Please see attached correspondence from Ms. Katherine Rubin, Director of Corporate Environmental Affairs, regarding Southern California Edison Ivanpah – Control Project – State Clearinghouse No. 2020-08-0553 – Draft Environmental Impact Report Comment Letter.

Subject: Southern California Edison Ivanpah-Control Project – State Clearinghouse
No. 2020-08-0553 – Draft Environmental Impact Report Comment Letter

Figure ES-2. Alternatives Retained

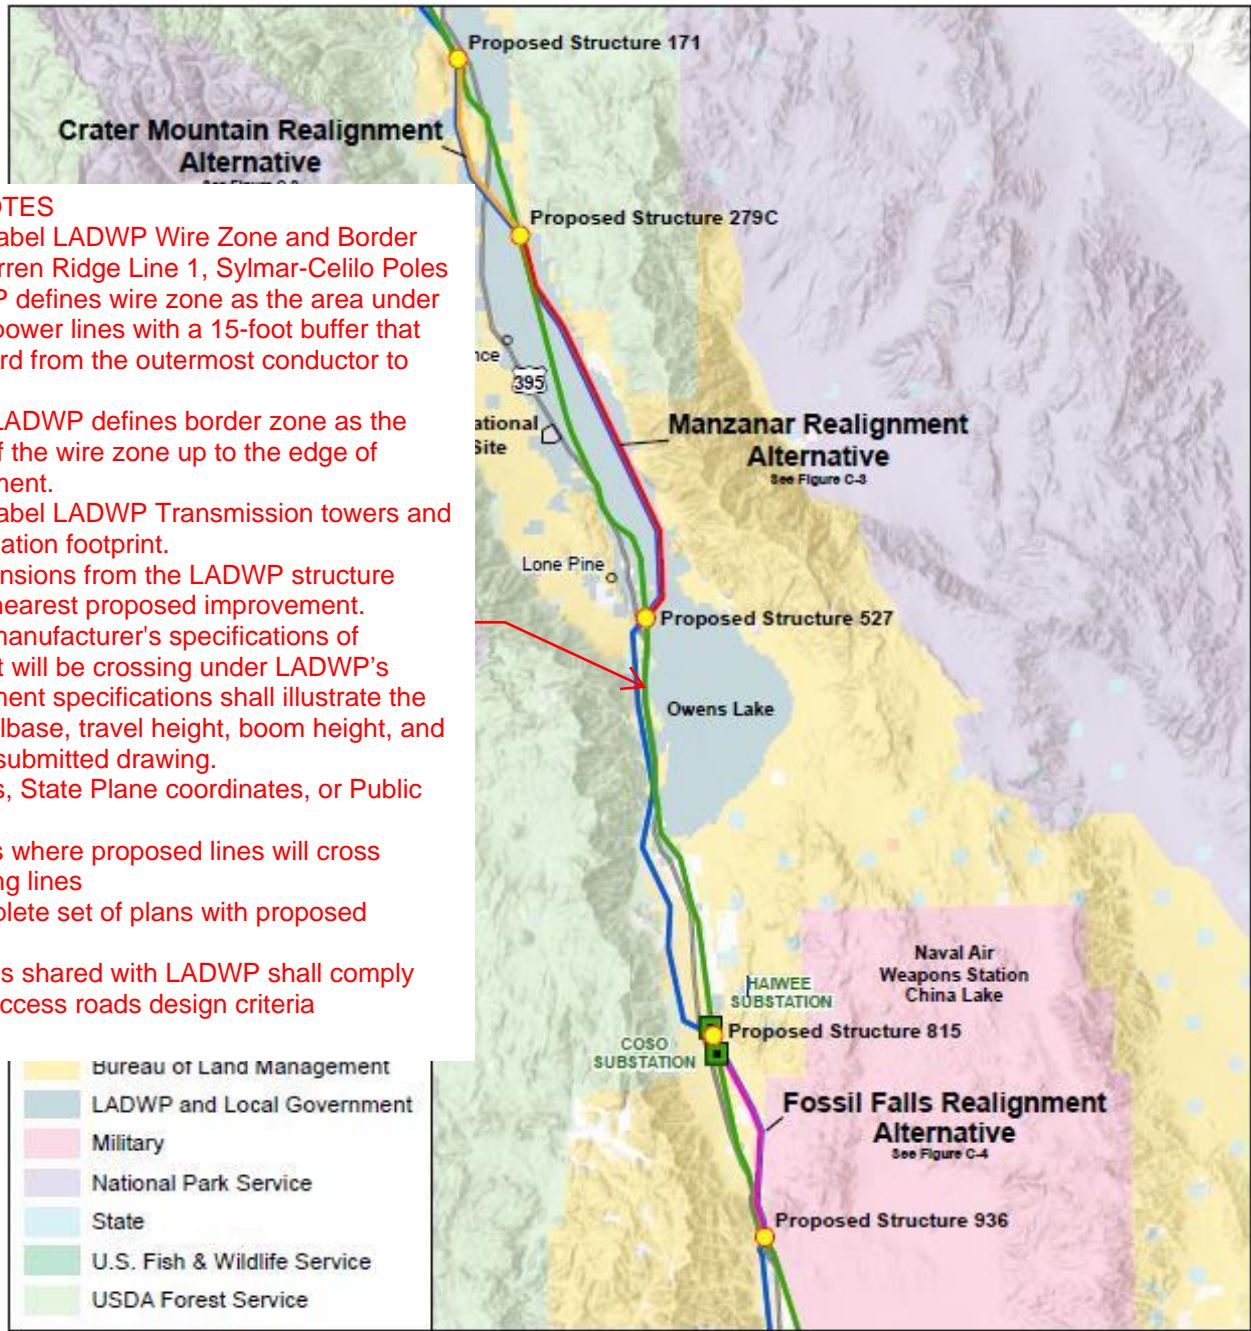
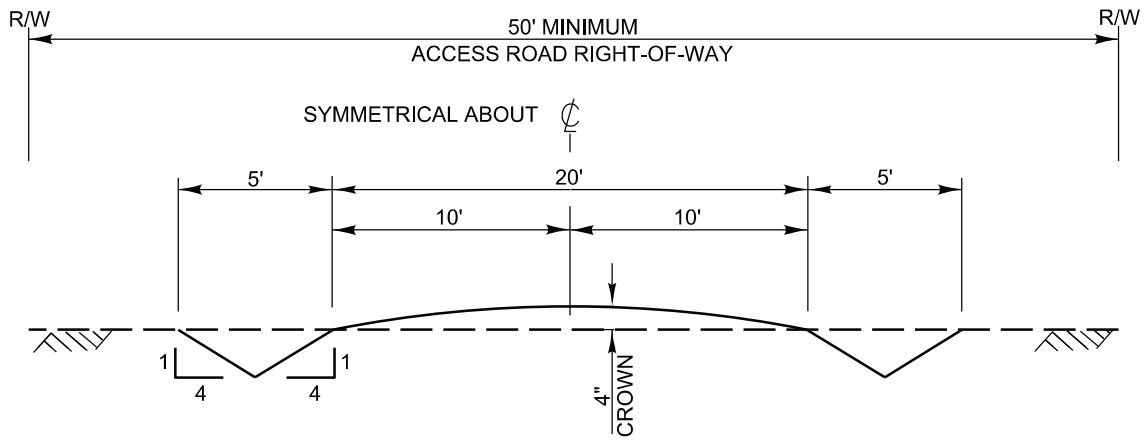
- GENERAL NOTES**
- Identify and label LADWP Wire Zone and Border Zone (Inyo-Barren Ridge Line 1, Sylmar-Celilo Poles 3 & 4). LADWP defines wire zone as the area under the overhead power lines with a 15-foot buffer that extends outward from the outermost conductor to provide a safety buffer. LADWP defines border zone as the area outside of the wire zone up to the edge of LADWP easement.

- Identify and label LADWP Transmission towers and illustrate foundation footprint.
 - Provide dimensions from the LADWP structure footing to the nearest proposed improvement.

- Provide the manufacturer's specifications of equipment that will be crossing under LADWP's TLRW. Equipment specifications shall illustrate the vehicle's wheelbase, travel height, boom height, and weight on the submitted drawing.

- Include APNs, State Plane coordinates, or Public Land Survey
 - Identify areas where proposed lines will cross LADWP existing lines
 - Provide complete set of plans with proposed changes.

- Access Roads shared with LADWP shall comply with LADWP access roads design criteria
